**RE: Smiles for Kids Dental Office – Phase 2**  
**Conceptual Grading and Drainage Plan**  
**Stamp Date: 6/1/17**  
**Hydrology File: C12D055**

Re: Tract 10-A-1 (Smile for kids Phase 2) / Hydrology File C12D055

**RE: Smiles for Kids Dental Office – Phase 2  
Conceptual Grading and Drainage Plan  
Stamp Date: 4/26/17  
Hydrology File: C12D055**

SECTION A - EAGLE RANCH ROAD - PROPOSED CROSS SECTION  
NTS

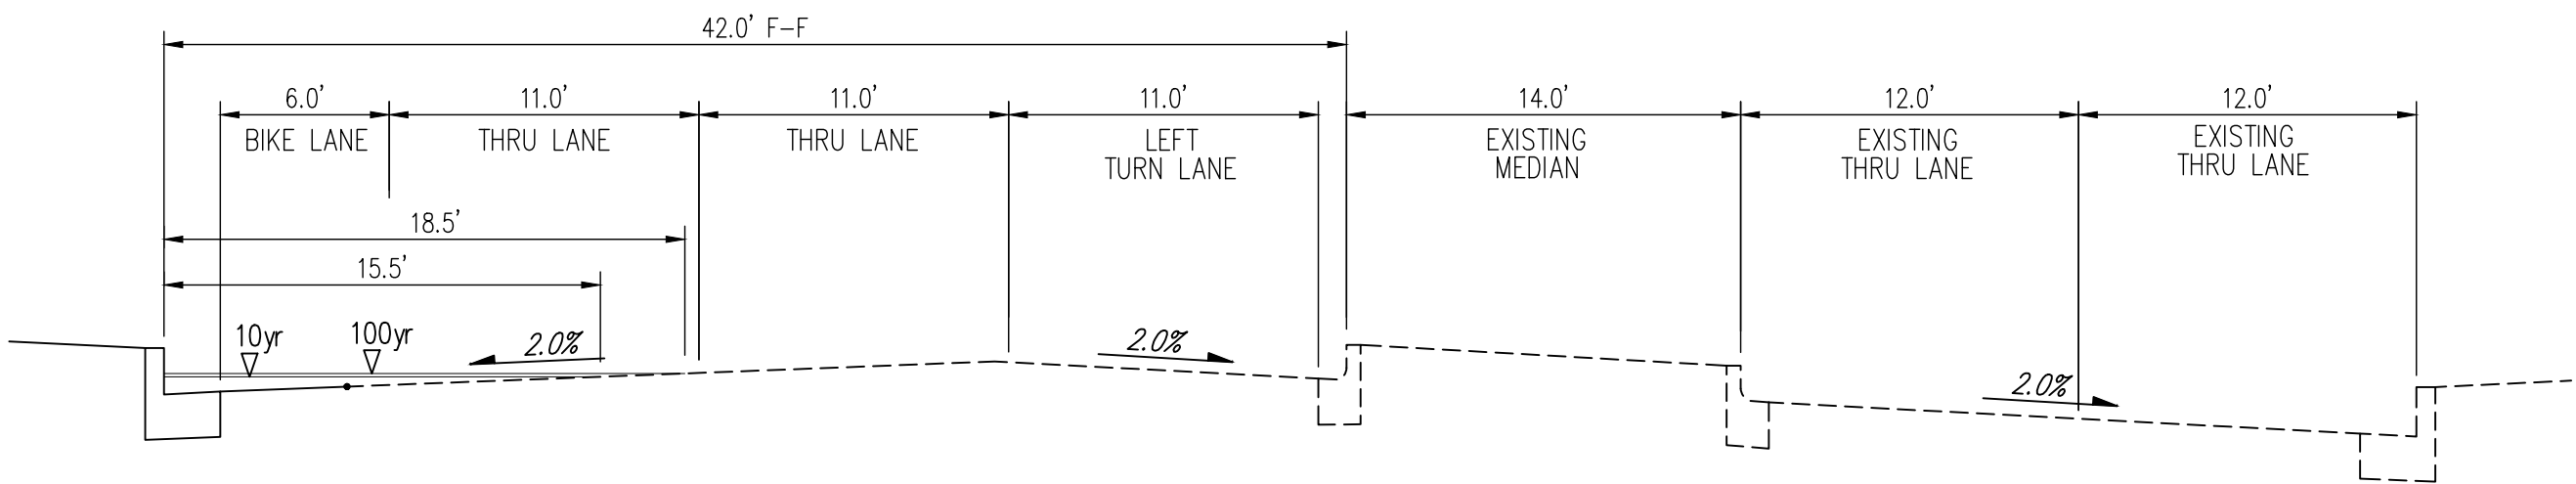
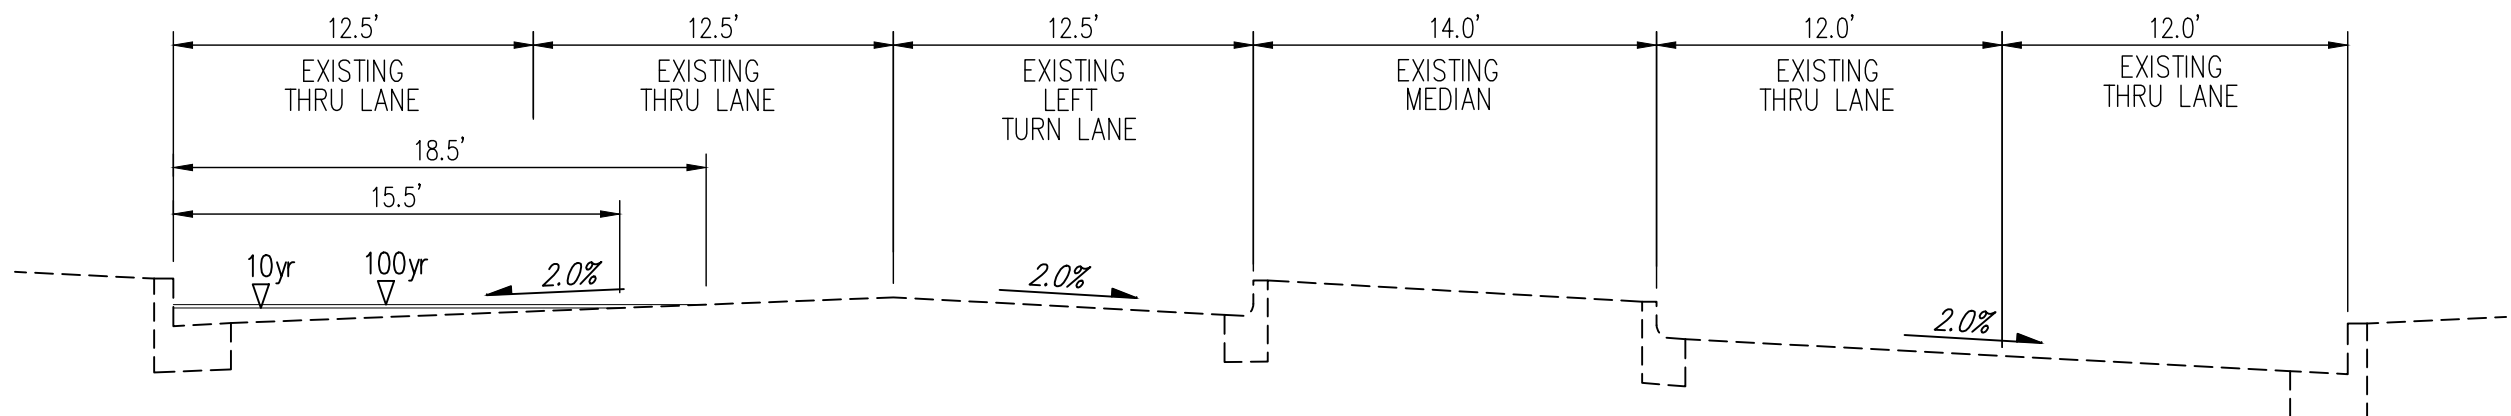
16. On Sheet C100. Please provide two cross sections of the proposed retention pond. One along Eagle Ranch Road and the other at the proposed sidewalk culverts on Nunzio Avenue.

19. Please note that according to the 2040 Metropolitan Transportation Plan, Eagle Ranch Road may be widened for a bike lane. Please check with Transportation and anticipate this in the pond design.

16. The cross sections along Nunzio and Eagle Ranch have been added.
17. The paved asphalt trail along Nunzio and concrete sidewalk along Eagle Ranch have been added.

19. We have discussed this with Transportation. The conceptual pond design has been modified based on widening of Eagle Ranch for a right turn lane and bike lane.

sheet  
**C100**

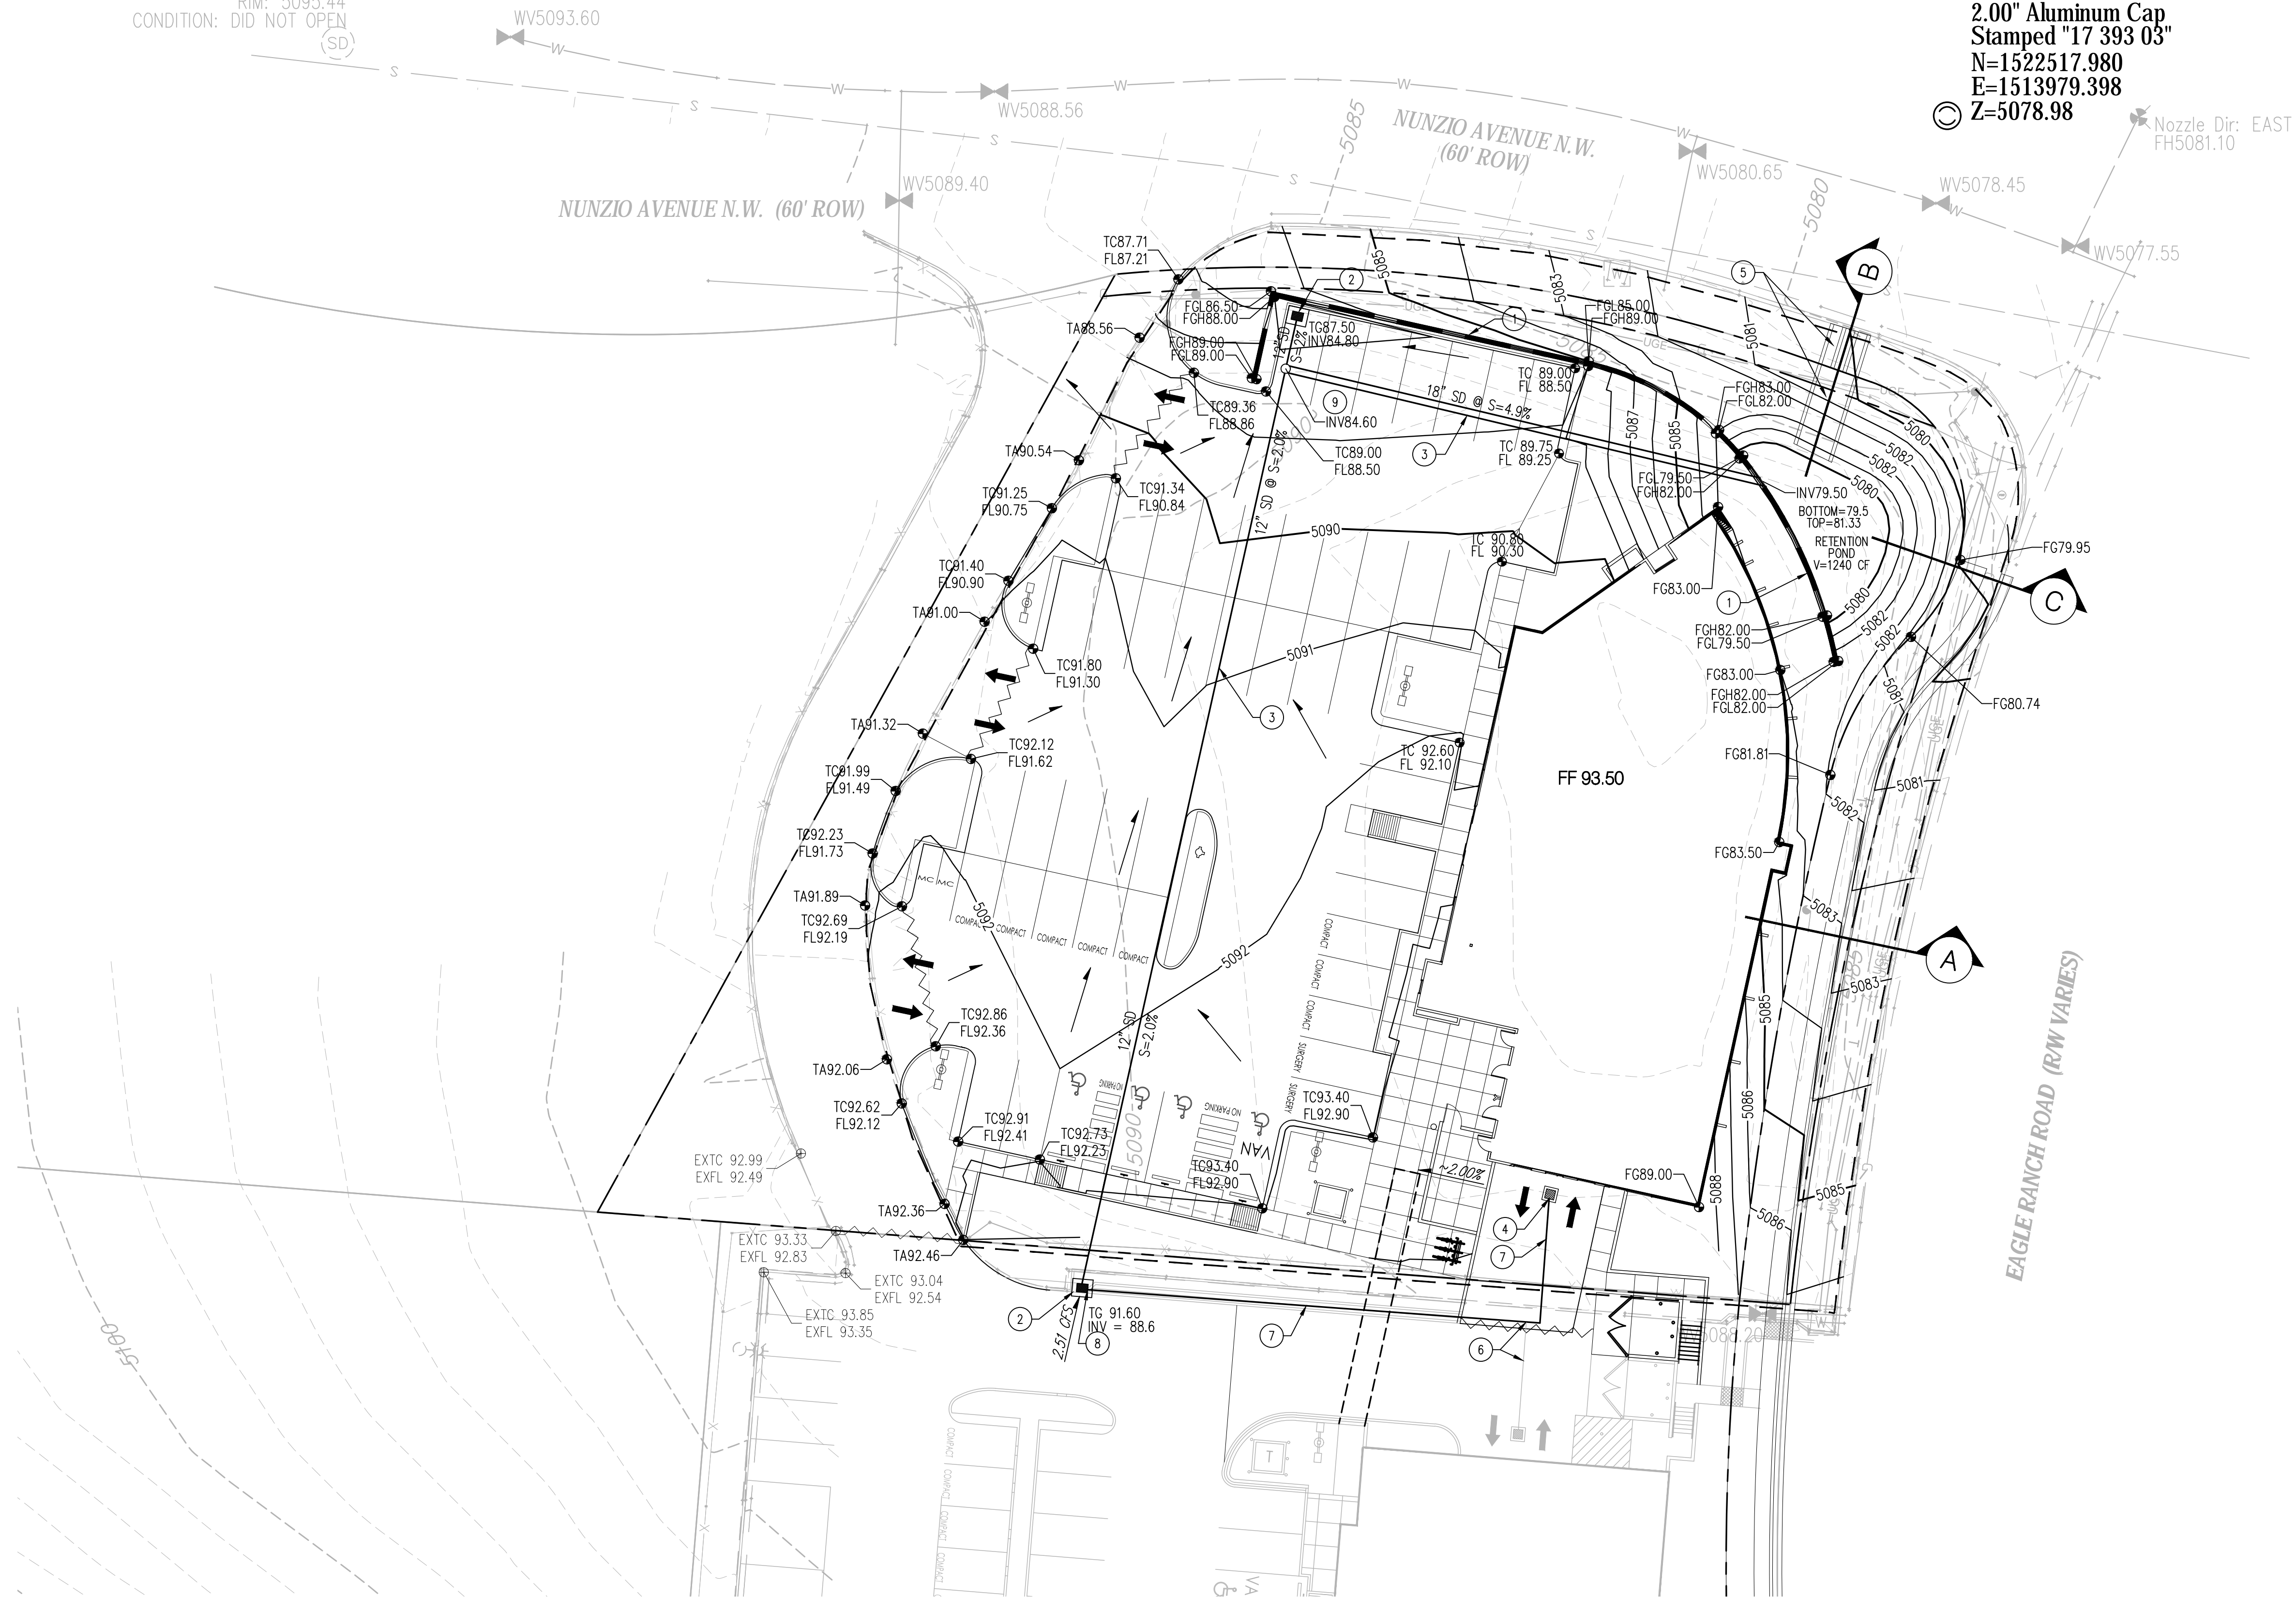
1. Please place a note **“Not for Construction”** on C001, C002, and C100.
2. On Sheet C001. Under the First Flush Calculations, the volume provided shows 1310 CF and the labeled volume of the pond is 1240 CF. Please correct whichever one is incorrect.
3. On Sheet C100. It appears that the proposed bike lane should continue to the corner of Eagle Ranch and Nunzio. This would mean that the pond will have to be shifted over a little bit and the valley cutter across Nunzio Avenue will have to be replaced to reflect the new bike lane. Please get the bike lane layout approved by transportation before resubmitting. Also please do not forget to place the valley gutter on the infrastructure list.

12. On Sheet C100. Please provide the existing TC & FL at the corners of the Phase 1 parking lot in a 70 foot radius around the proposed inlet. I would like to insure the drainage pattern for the proposed inlet.

13. On Sheet C100. Along the existing access drive, please provide the existing TC & FL at the proposed curb return for the parking lot entrances.
14. On Sheet C100. There is an existing inlet for the Phase 1 underground parking. This inlet has a sump pump and a pvc discharge pipe that goes into the existing concrete rundown. See photo below. The Phase 2 plan does not show that there is a connection to the proposed storm sewer system. Please provide the connection.

15. On Sheet C100. The Phase 2 underground parking has a proposed inlet without a connection to the proposed storm sewer system. Please provide the connection.

17. On Sheet C100. Lot 10 A-1 and Tracts G & H are not included in the Fountain Hill financial deferment of the sidewalks. Therefore please show the sidewalk along Nuzio Avenue and Eagle Ranch Road.

12. Top of curb and flow line elevations have been added.
13. Top of curb and flow line elevations have been added.

14. The Phase 1 storm drain sump pump discharge line connection has been added. This discharge line will connect to a new inlet on Tract H.
15. The Phase 2 storm drain sump pump discharge line connection has been added. This discharge line will connect to the Phase 1 line and new inlet on Tract H.
